**MONTGOMERY COUNTY HISTORIC PRESERVATION COMMISSION**  
**STAFF REPORT**

<b>Address:</b>	19 Quincy Street, Chevy Chase	<b>Meeting Date:</b>	6/28/2023
<b>Resource:</b>	Contributing Resource <b>Chevy Chase Village Historic District</b>	<b>Report Date:</b>	6/21/2023
<b>Applicant:</b>	Julia P. Martin and Ignacio Quintana (Jamie Newell/Johnson's Landscaping, Agent)	<b>Public Notice:</b>	6/14/2023
<b>Review:</b>	HAWP	<b>Tax Credit:</b>	No
		<b>Staff:</b>	John Liebertz

**PROPOSAL:** Hardscape and fence installation.

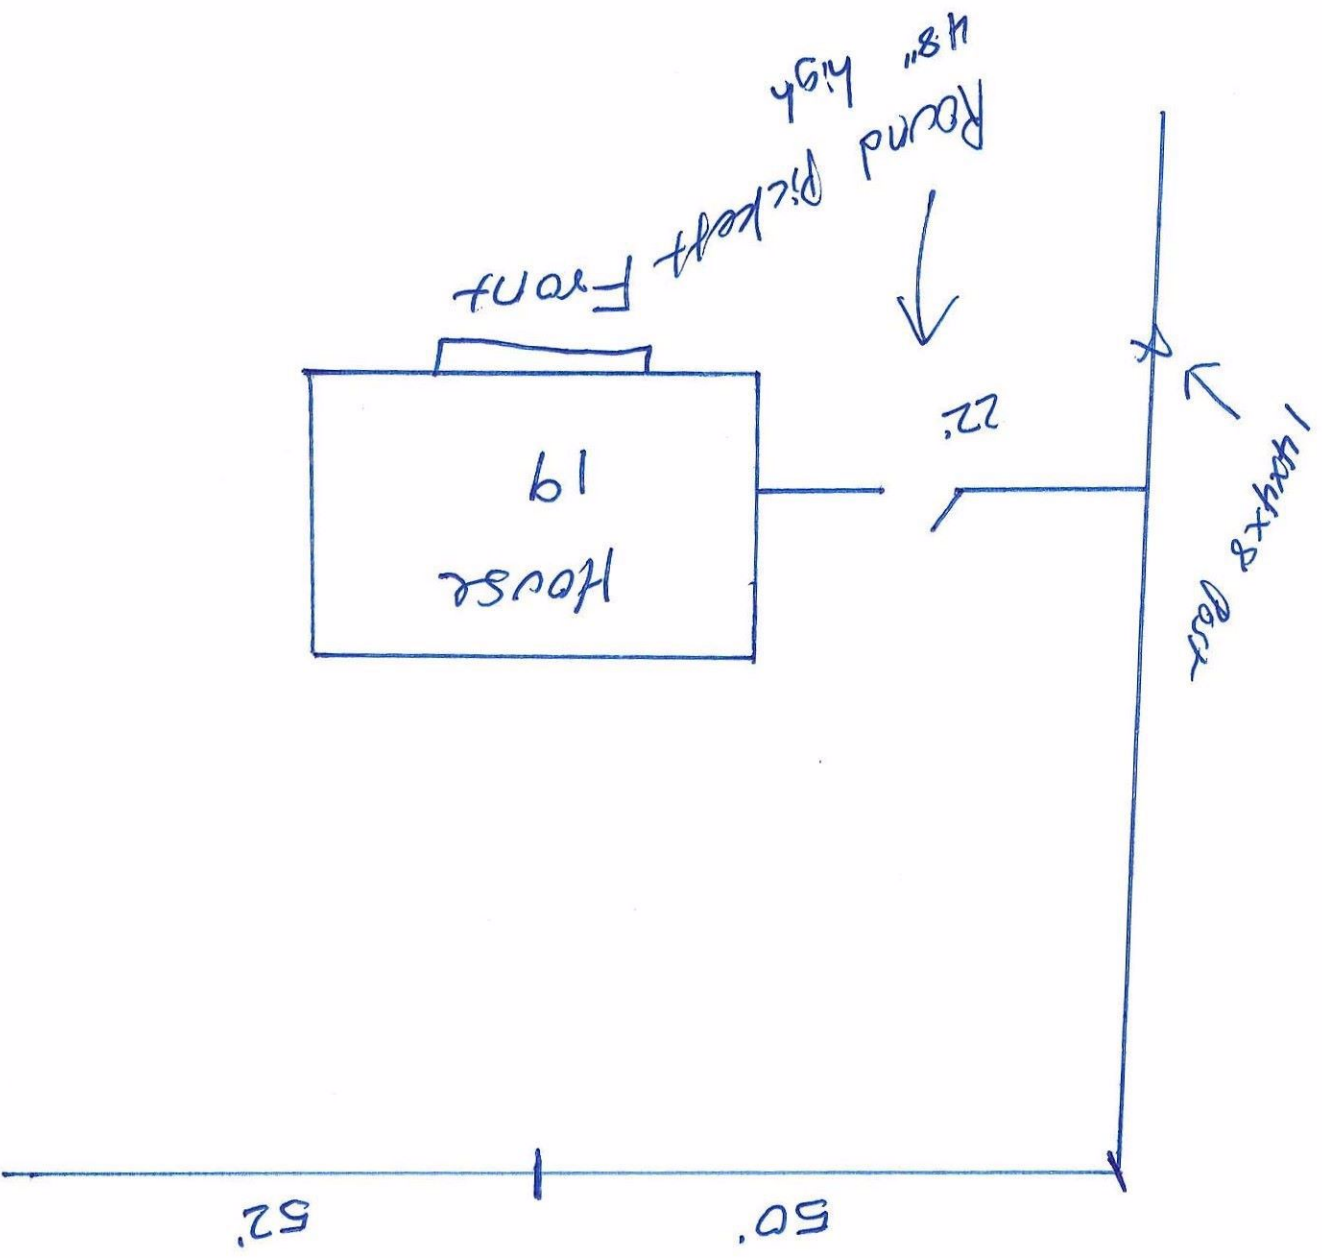
Staff finds the removal, replacement, and installation of the proposed fencing to be consistent with the applicable guidelines and recommends approval with conditions. Staff reviewed the fence installation with “moderate scrutiny” for the side yard fence and “lenient scrutiny” for the rear yard fence per the guidelines. The proposed wood picket fence (in the side yard) would replace an existing wood picket fence located 10’ to the north. The new fence would have limited visibility from the public rights-of-way due to its deep setback from the at the rear corner of a screened-in porch and dense foliage. The design and materials of the proposed fence match the existing fence to be removed. Therefore, the side yard fence would have no adverse effect on the character of the individual resource or the park-like setting of the historic district and should be approved as a matter of course. Staff, however, requests that the applicant submit: 1) a photograph, elevation, or sketch of the proposed gate; and 2) note on the submission materials that the post caps will be wood. The quote from Accokeek Fence Company, Inc. includes a check next to “black post caps” instead of the “wood caps” referenced later in the application.

1. The applicant shall submit a photograph, elevation, or sketch of the proposed gate.
2. The applicant shall clarify on the submission materials that all post caps would be wood.
